Subject: U-2579 D, E,& F Request for Modification to Individual Section 404 and Section 401 Water Quality Certification

Subject: **Request for Modification to Individual Section 404 and Section 401 Water Quality Certification** for the Winston-Salem Northern Beltway from US 52 to US 311 (New Walkertown Road), Forsyth County. Federal Aid Project No. NHP-0074(213), TIP Nos. U-2579D, E& F. Division 9.

Permit Impact Site Modifications

| PROJECT REFERENCE NO. U-2579D, E & F | SHEET NO. 24 |

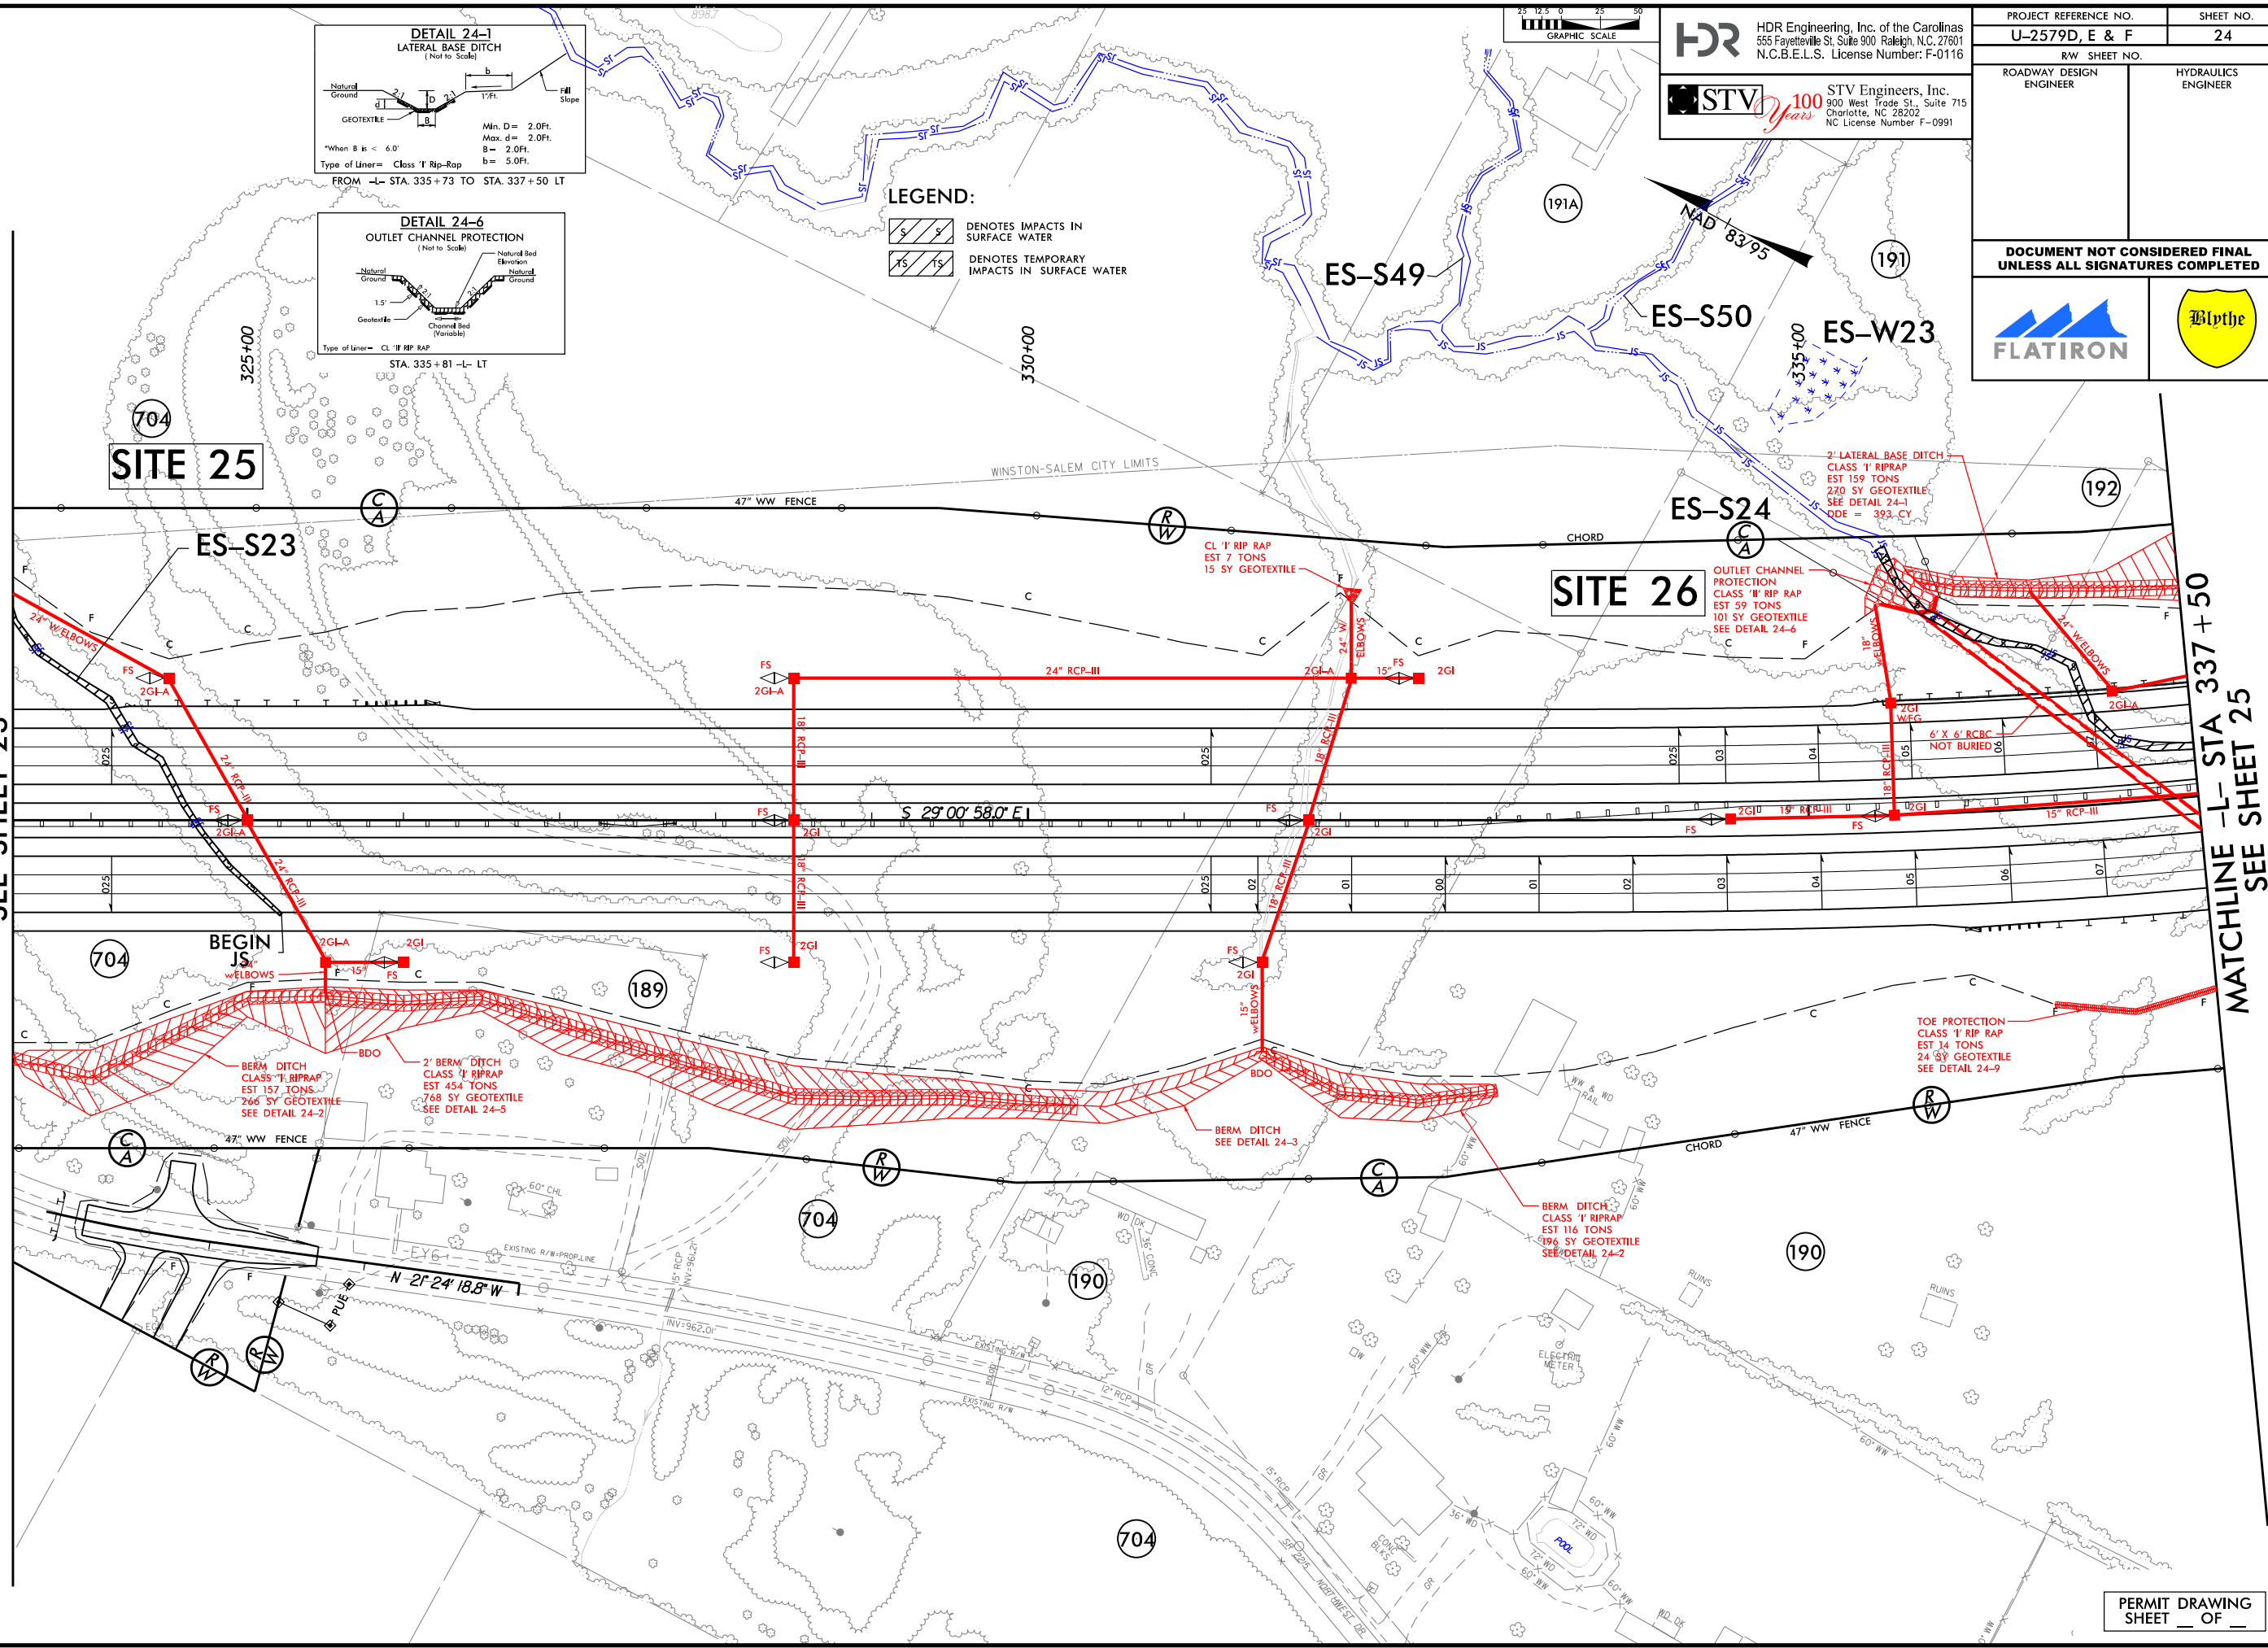
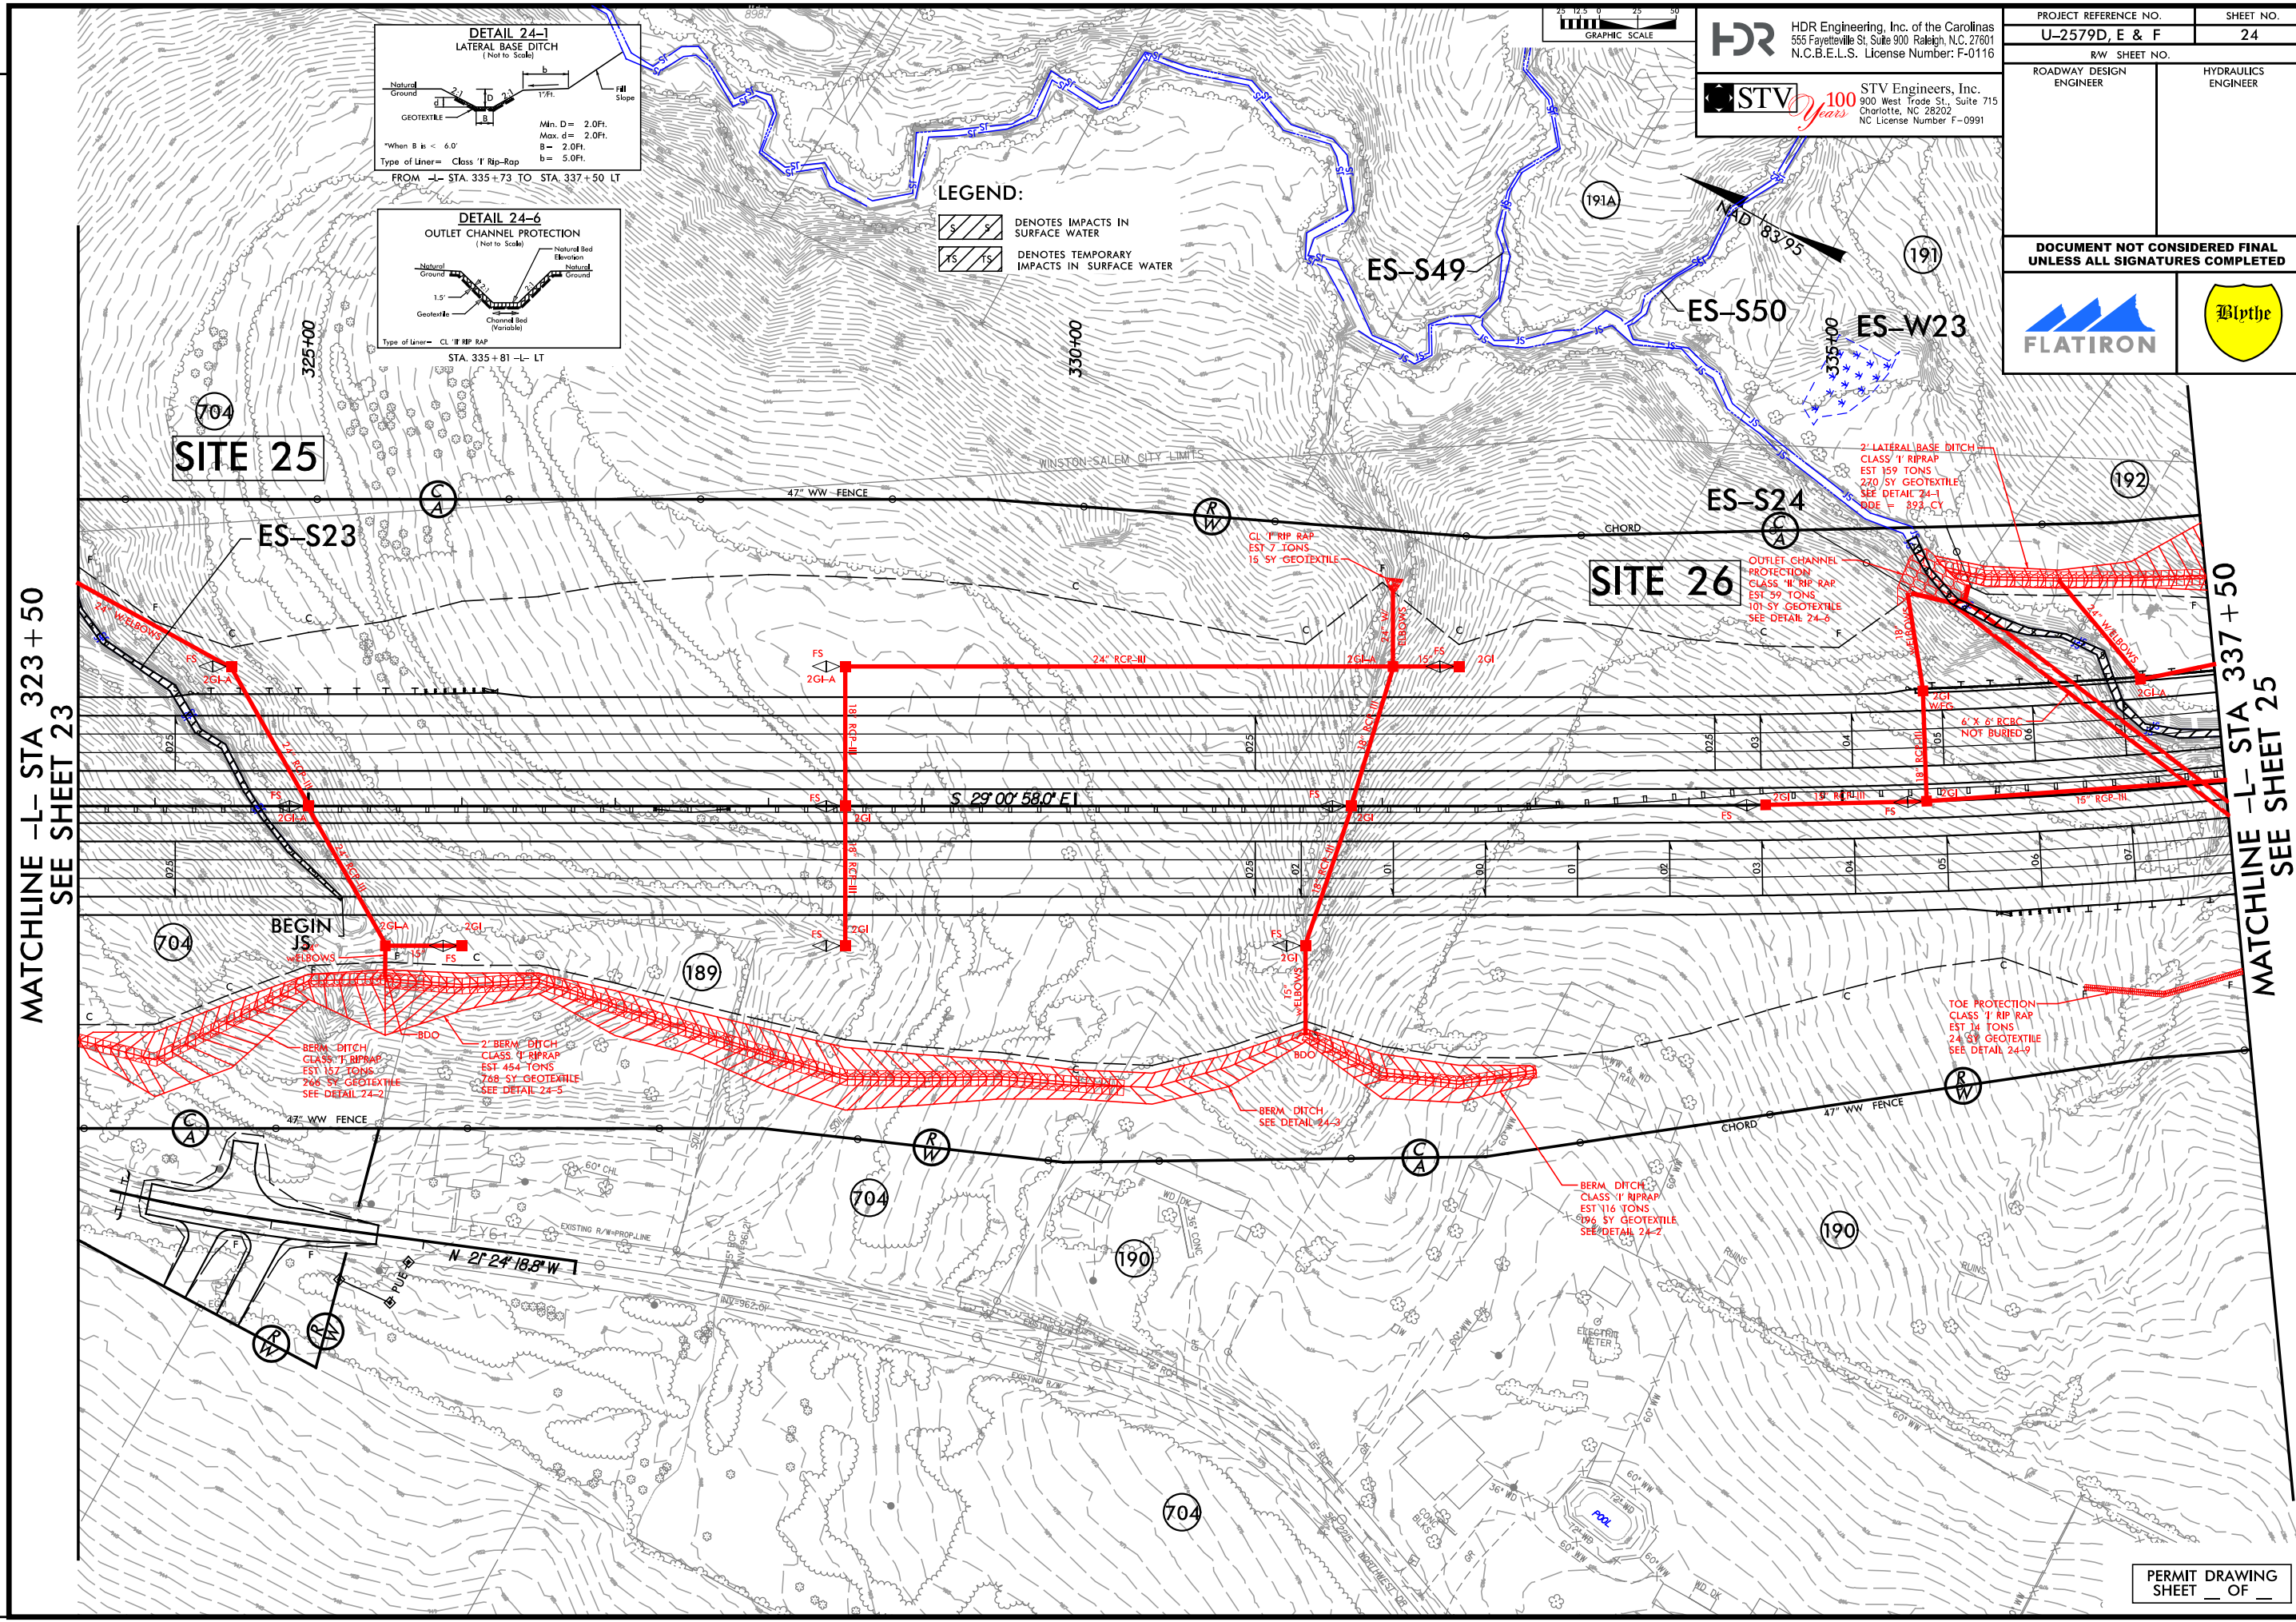
Site 26 (Sheets 24 and 25): Site 26 impacts changed as a result of the final design of the 6x6 RCBC in which the culvert length was increased from preliminary plans. When reviewed with the previous modification the new culvert length resulted an increase in permanent impacts by 4 linear feet for the RCBC and by 5 linear feet for bank stabilization. The temporary impact at this site was reduced by 2 linear feet. There will be a total of 523 linear feet of impact due to the RCBC, 29 linear feet of bank stabilization, and 18 linear feet of temporary stream impact at Site 26.

SITE 27

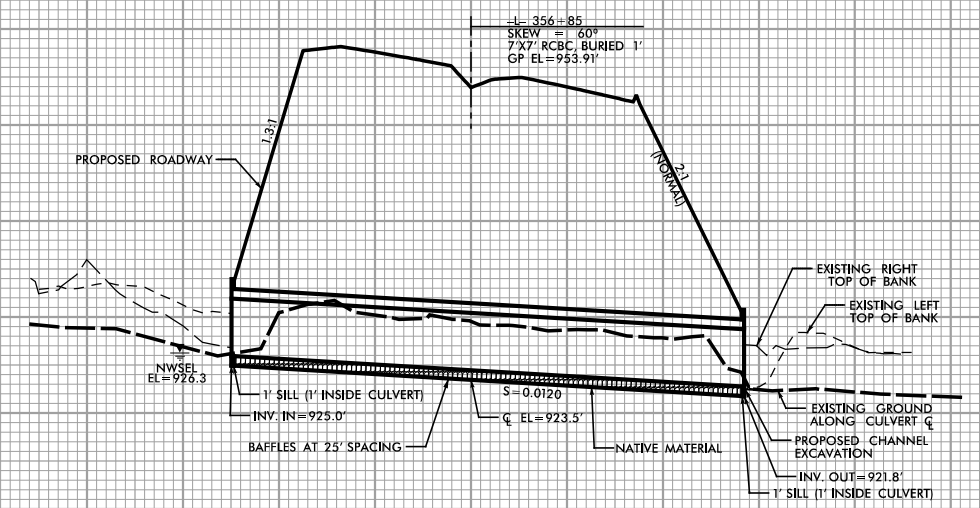
This permit modification package also includes revised drawings for Permit Impact Sites 5, 7, 13, 15, 17, 19, and 27. These sites have changed slightly due to the final culvert design as illustrated on the attached plan sheets; however, the impacts at these sites did not change from the previous modification referenced above. The culvert length increased by no more than 5 feet and decreased in length by no more than 20 feet at an individual site. The slight changes in length were captured in the previous plans as permanent impacts due to the inlet or outlet channel protection. The attached plans sheets have been provided to replace the previous plan sheets.
